Application for New Single Family Residential Construction (One or Two Units)

Zoning Plan Examination Checksheet Response

BES PLAN EXAMINATION CHECK SHEET

Job Name: Alta Mira Residence
FE Job #: 15-T070
Re: Structural Plan Review

FB3 a.wwb

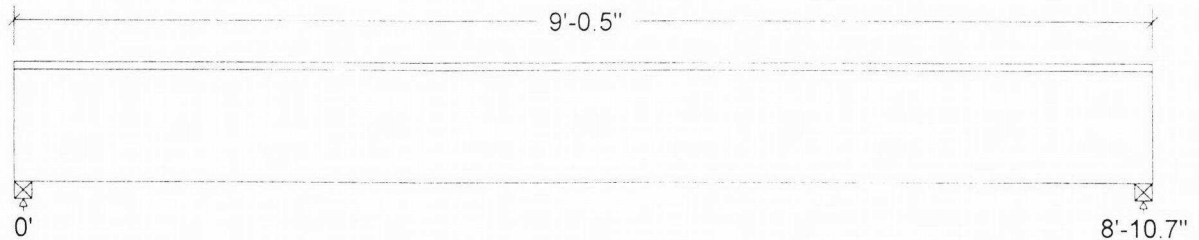
C6 shows the calculation for support of FB3 only. FB3 occurs at 2 locations and now spans 8'-9". See attached revised calculation for FB3 specifying a 5-1/8"x10-1/2" GL beam. The total reaction for FB3 is 5773 lbs. C6 posts down on retaining wall footings with a minimum width of 2'-3". No additional spread footings are needed at these columns. C6 can be a (2)-2x6 DF #2 post – see attached calculation.

Glulam-Unbal., West Species, 24F-1.8E WS, 5-1/8"x10-1/2"
